PRODUCT / PROCESS CHANGE NOTIFICATION

1.1 Company	 STMicroelectronics International N.V
1.2 PCN No.	EMBEDDED PROCESSING/26/16388
1.3 Title of PCN	ST Shenzhen (China) assembly site and HHgrace (China) Diffusion site additional source for STM32H74x and STM32H75x listed products in LQFP 14x14 packages.
1.4 Product Category	STM32H742x, STM32H743x, STM32H750x and STM32H753x
1.5 Issue date	2026-07-07

**ST Shenzhen (China) assembly site and HHgrace (China)
Diffusion site additional source for STM32H74x and STM32H75x
listed products in LQFP 14x14 packages.**

Table 1: Front-End Diffusion / Back-End Sites traceability

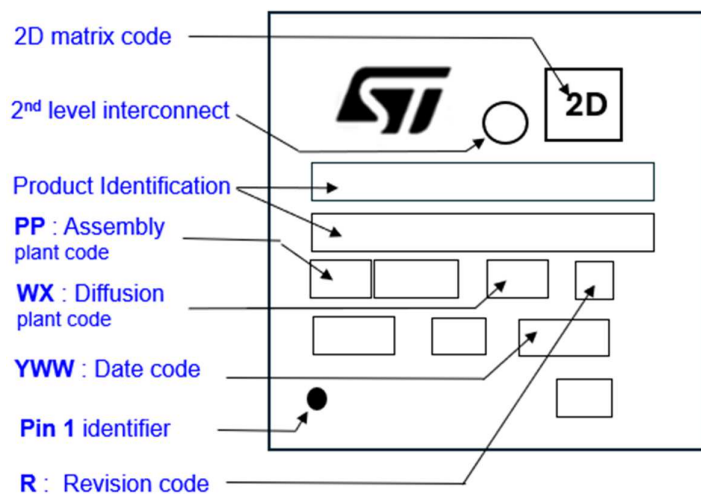
Current condition	New condition	
Front-End Diffusion site	ST Crolles 300 (France)	HHGrace WuXi (China)	
		Fab 7	Fab 9
	STM32H75x, STM32H74x		
Die revision Marking R	“V”	“2”	“3”
Diffusion plant code WX	“VQ”	“Y5”	“2E”

Back-End Assembly sites	Existing Back-end	Added Back-End Site
Assembly plant code PP	AA: ASE KaoHsiung (Taiwan) 99: ST Muar (Malaysia) 7B: AMKOR ATP (Philippines)	GK: ST Shenzhen (China)

Table 2: Marking Example with STM32H743VGT6 Commercial product

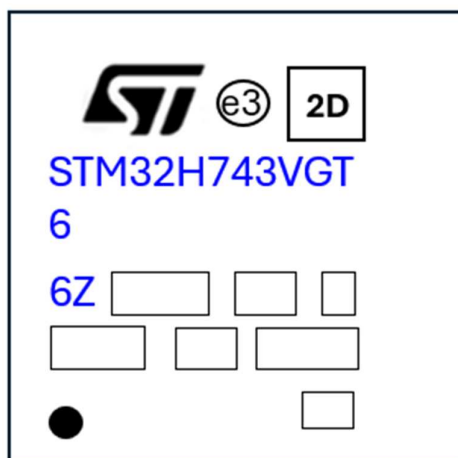
6.1 Description	Change is visible on the marking - Back-End Assembly Site code: • 7B : AMKOR ATP (Philippines) • AA : ASE KaoHsiung (Taiwan) • 99 : ST Muar (Malaysia) • GK : ST Shenzhen (China) New Assembly site - Diffusion plant code WX: • VQ : ST Crolles 300 (France) • Y5 : HHGrace WuXi (China) Fab 7 New Diffusion site • 2E : HHGrace WuXi (China) Fab 9 New Diffusion site Please refer to PCN 16388_Additional information.pdf document for further details.
------------------------	---

Table 3 : Back-End assembly Sites for LQFP 100L 14x14 packages

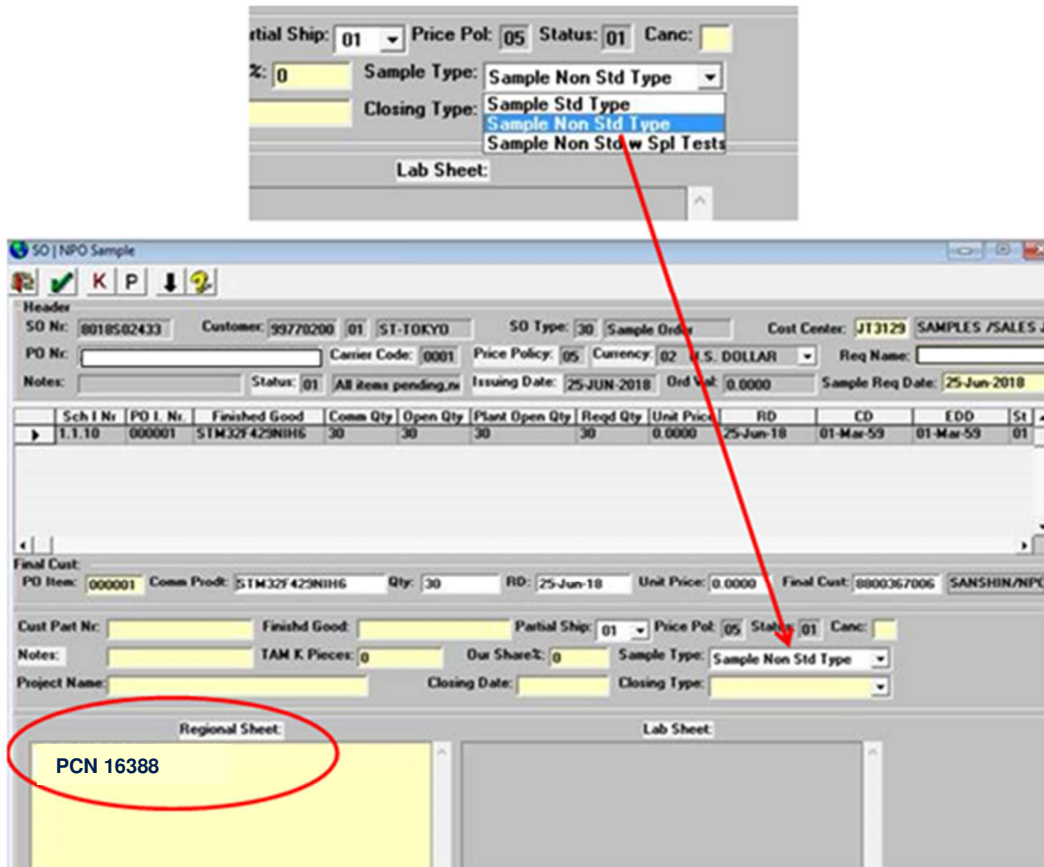
LQFP 100L 14x14	Existing back-End assembly lines				Added Line
Assembly Plant	Amkor ATP (Philippines)		ASE Kaohsiung (Taiwan)	Muar (Malaysia)	ST Shenzhen (China)
Leadframe	Copper, post-plated				Post-Plated
Ledfinishing ⁽¹⁾	Pure Tin (e3)				Pure Tin (e3)
Molding Compound ⁽²⁾	EME-G631SHQ		EME-G631SH	EME-G700LS	EME-G700LS
Glue / Die Attach	AP4200	Ablestik 3230	EN4900G	Ablestik ABP8302	Ablestick 8303A
Wire bonding	Gold 0.8Mils	Copper Pd 0.8Mils	Copper Pd 0.8Mils	Copper Alloy 0.8Mils	Copper Alloy 0.8Mils
Marking	2D MARKING

Pin1 identifier may change in terms of size and positioning however remaining near pin1's edge.

Marking position and size may be different upon assembly site, without any loss of information.
